APPENDIX F
REVISED PLAN CHANGE PROVISIONS

Queenstown Lakes District Council

**Proposed Plan Change 4
North Three Parks**

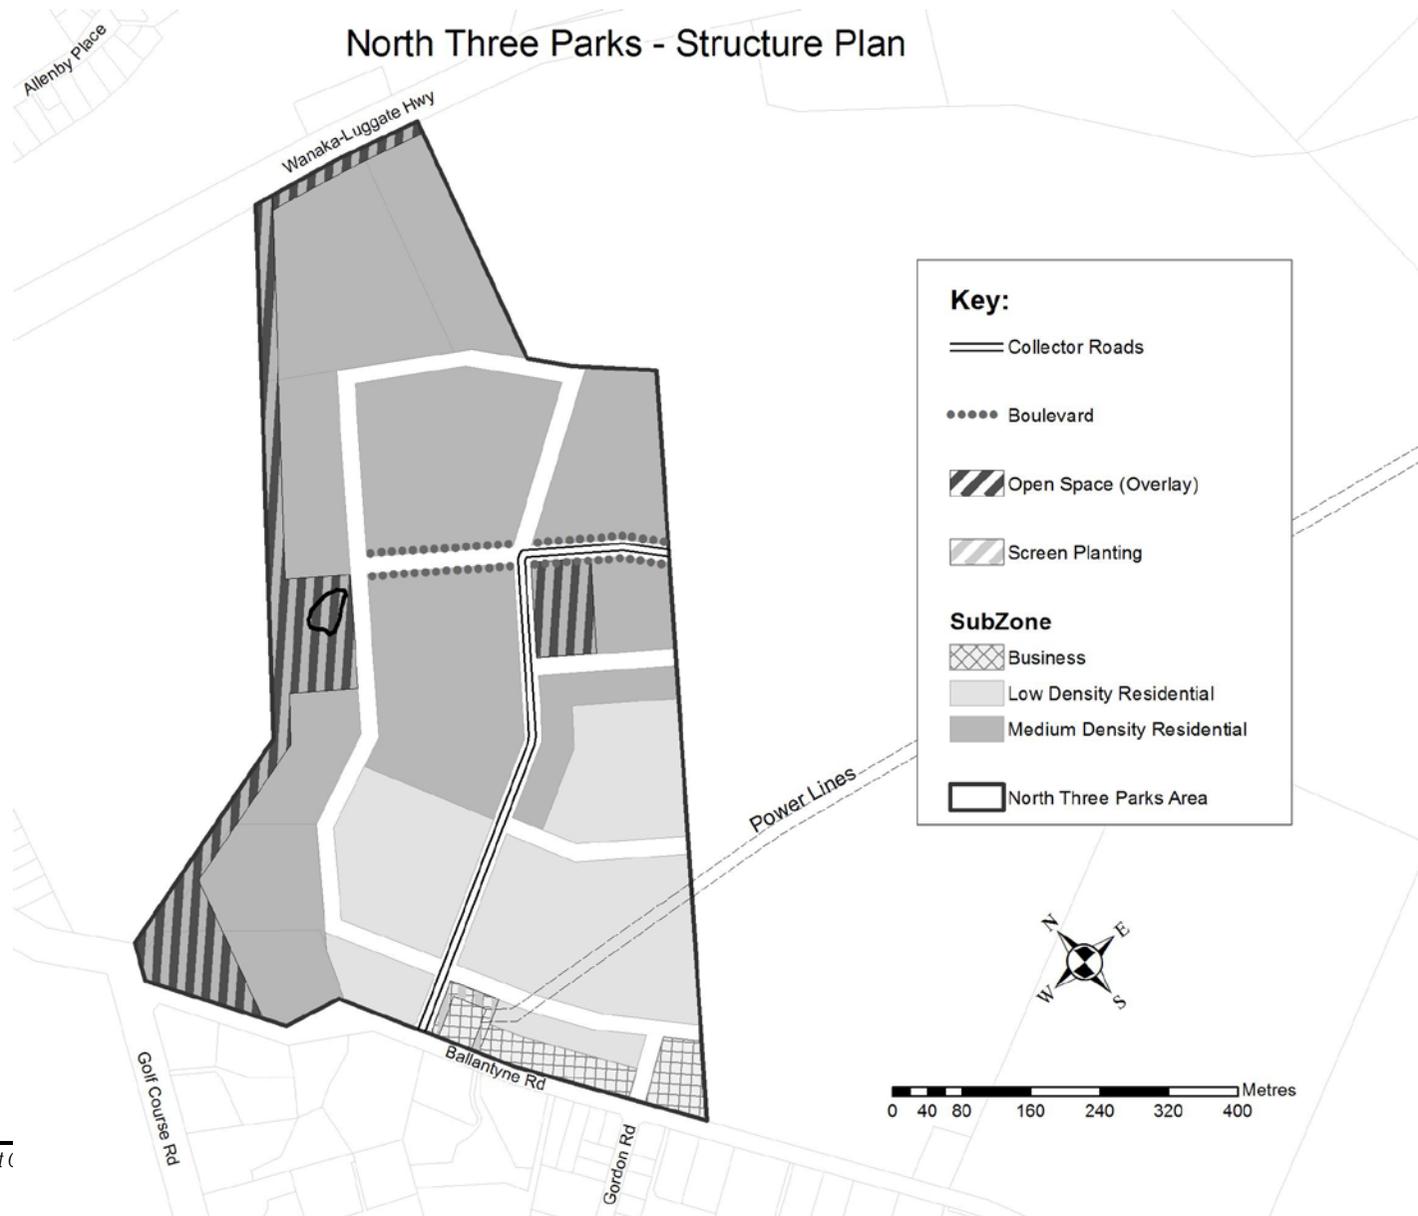
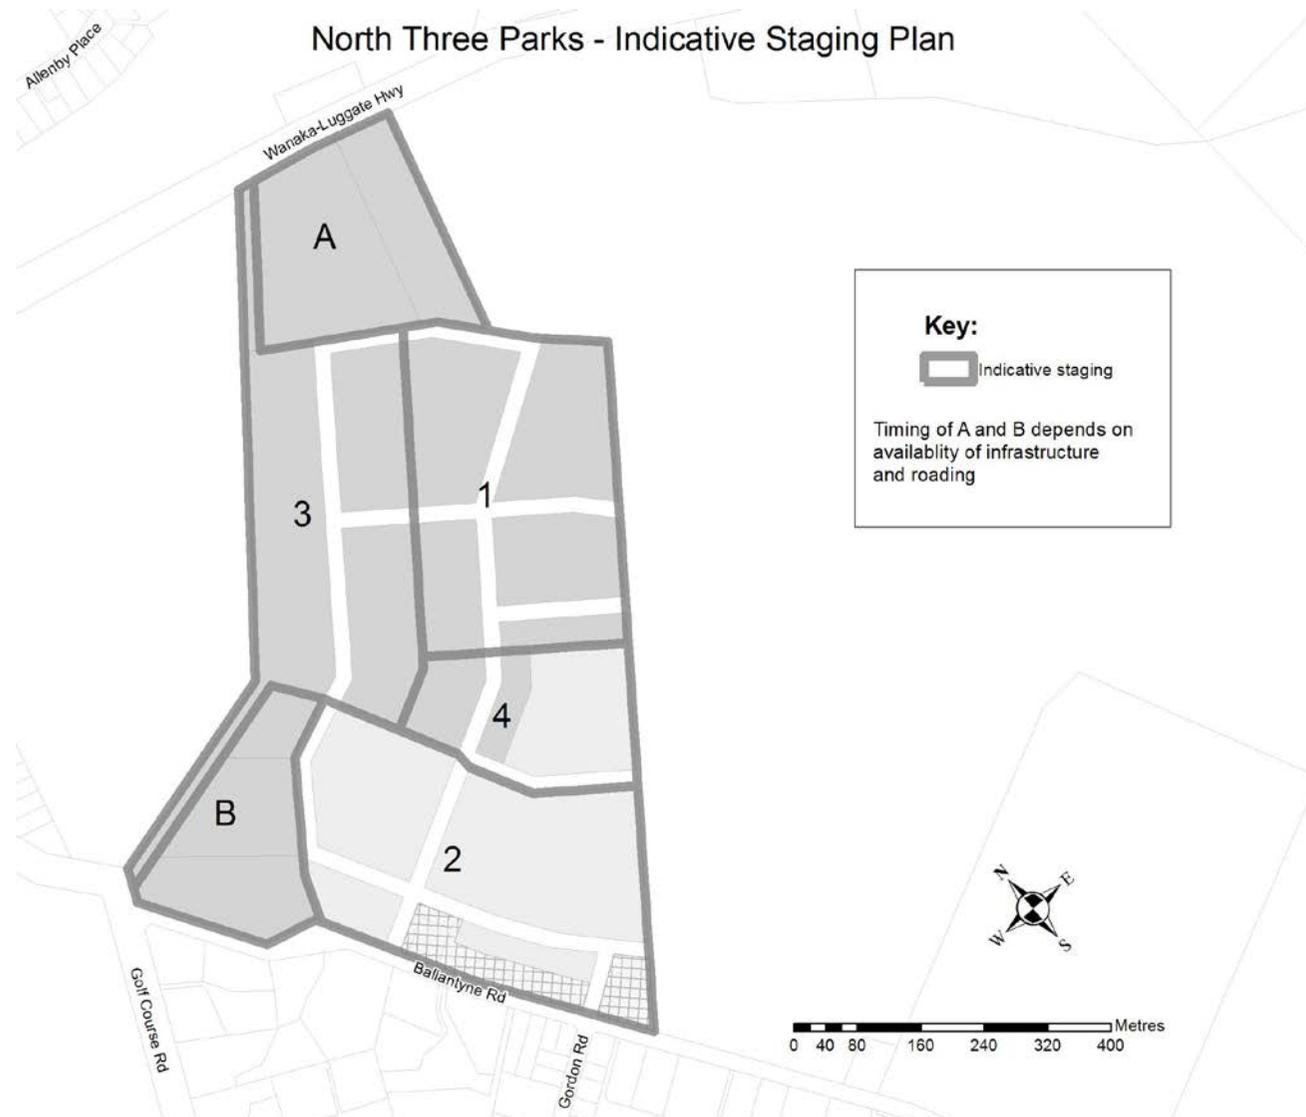
- (b) An additional area of land (North Three Parks) to the Three Parks Zone by adding this area of land to Section 12.25.3 Three Parks Structure Plan, Indicative Staging Plan and Open Space Plan as follows:

Indicative layout for residential land use abutting the linear park by the golf course in the North Three Parks area.

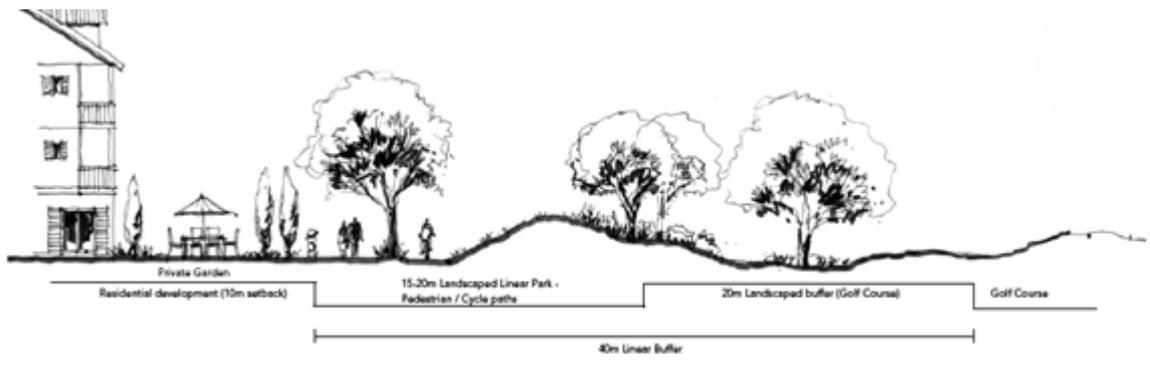
- (h) Another diagram and heading showing another option for an acceptable relationship between residential land use and open space where medium density residential abuts the linear park along the golf course as shown in the North Three Parks Urban Design Framework as follows:
